Preliminary Consultation
MONTGOMERY COUNTY HISTORIC PRESERVATION COMMISSION
STAFF REPORT

Address:	10305 Armory Avenue, Kensington	Meeting Date:	5/22/2024
Resource:	Primary Two Resource Kensington Historic District	Report Date:	5/15/2024
Applicant:	Village Concrete (Agostino Costa, Agent)	Public Notice:	5/8/2024
Review:	Preliminary Consultation	Tax Credit:	Partial
Permit Number:	n/a	Staff:	Chris Berger
PROPOSAL:	Demolition, two-story rear addition, and various alterations.

10305 ARMORY AVE HAWP PRELIM SUBMISSION

10305 ARMORY AVE
EXISTING SITE PLAN

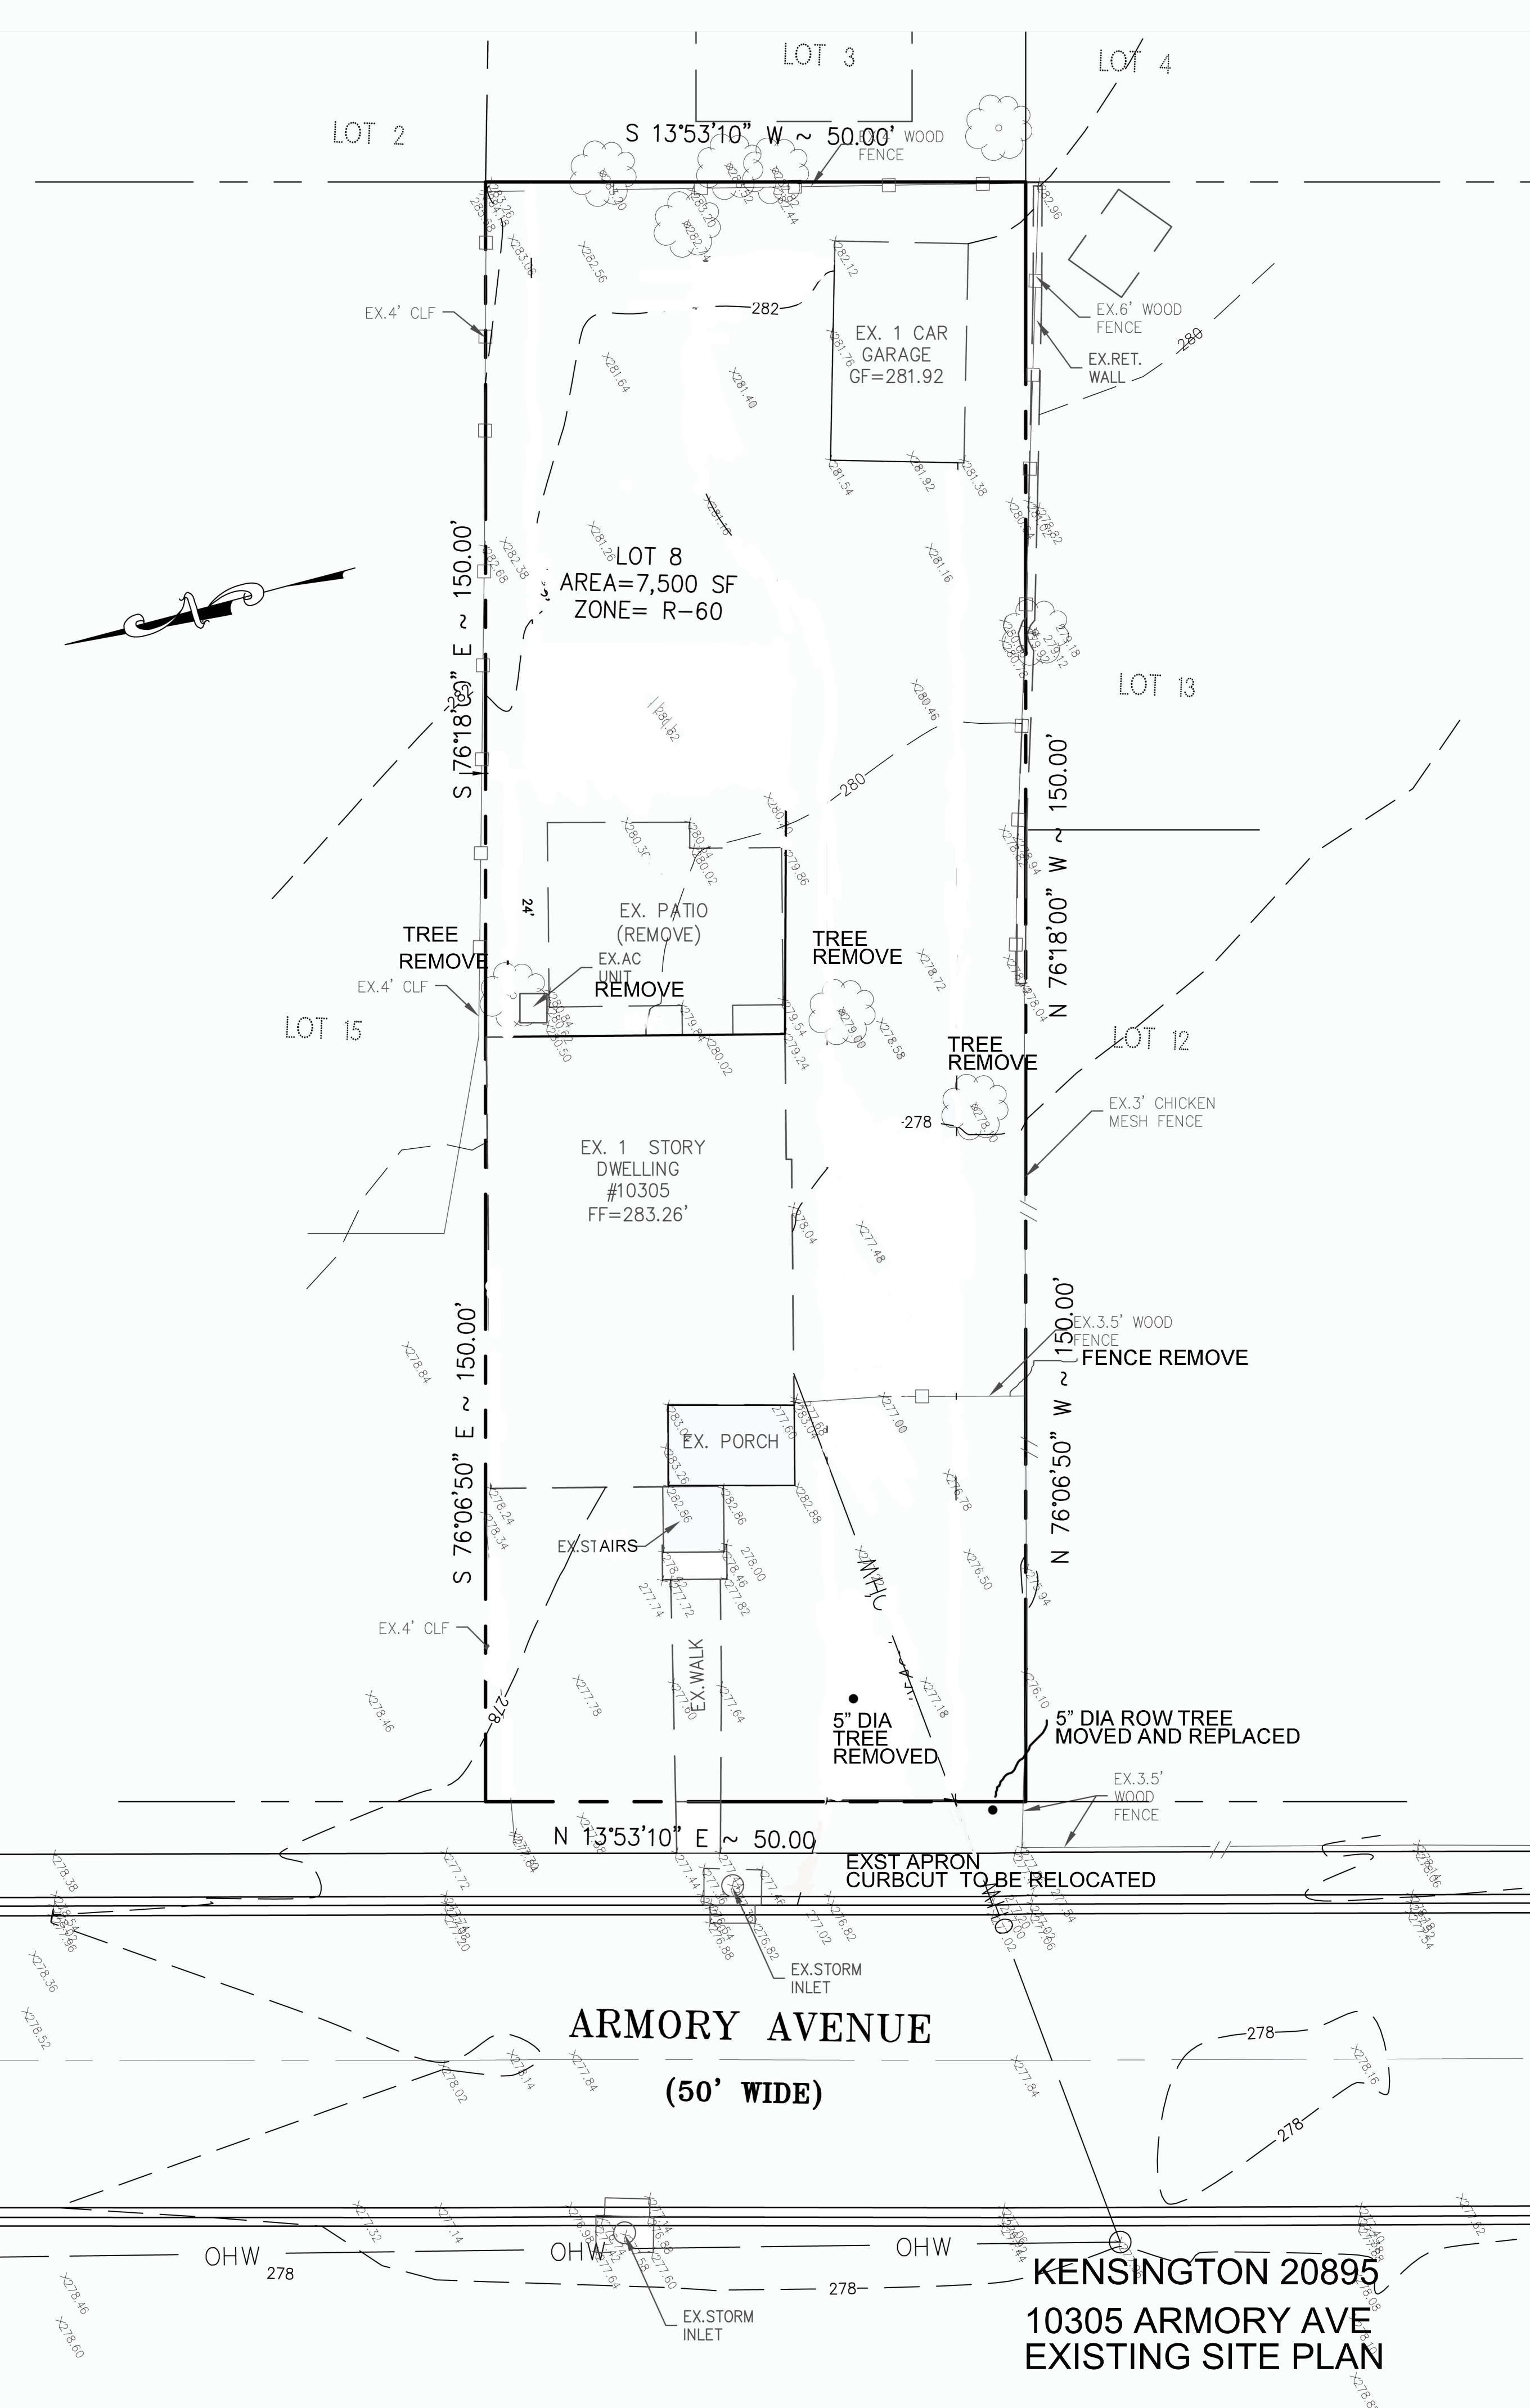
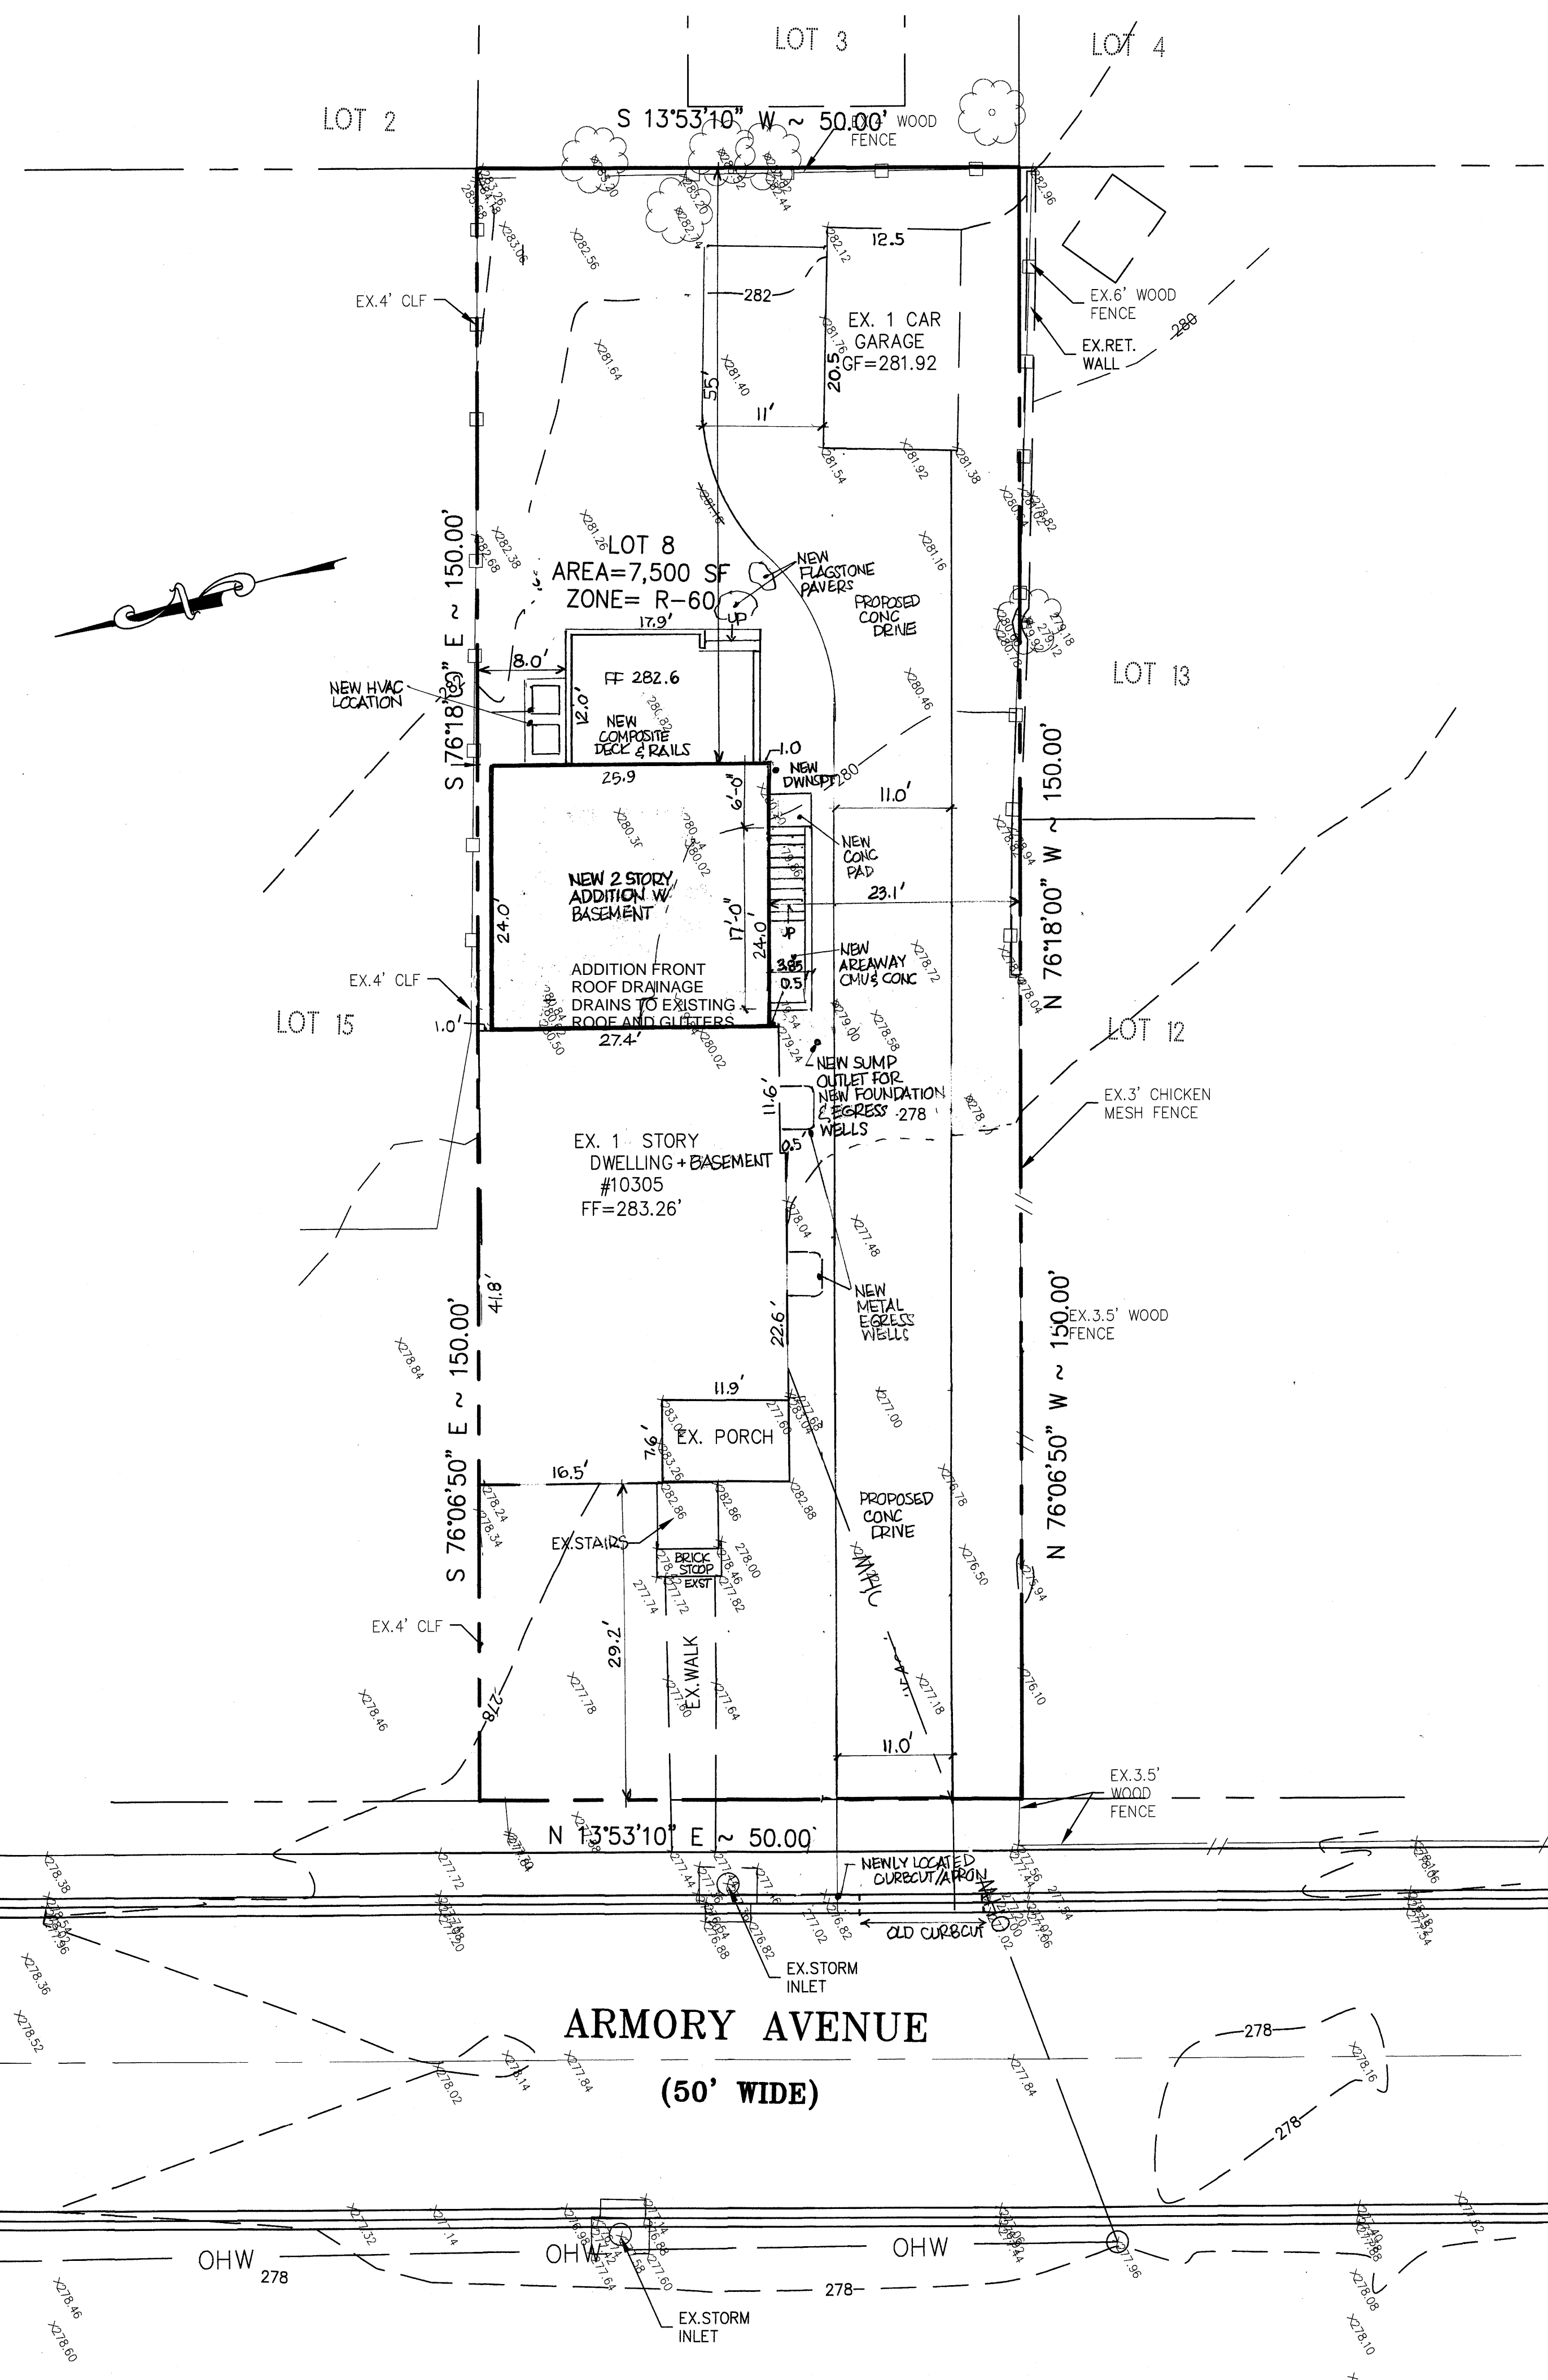
- Include existing and proposed roof pitches on the elevations. [NOW INCLUDED](#)
- Include a detailed existing site plan with dimensions showing the current conditions and a proposed site plan. Include any changes to the site, including tree removals, drainage, etc. [EXISTING AND PROPOSED SITE PLAN NOW INCLUDED.](#)
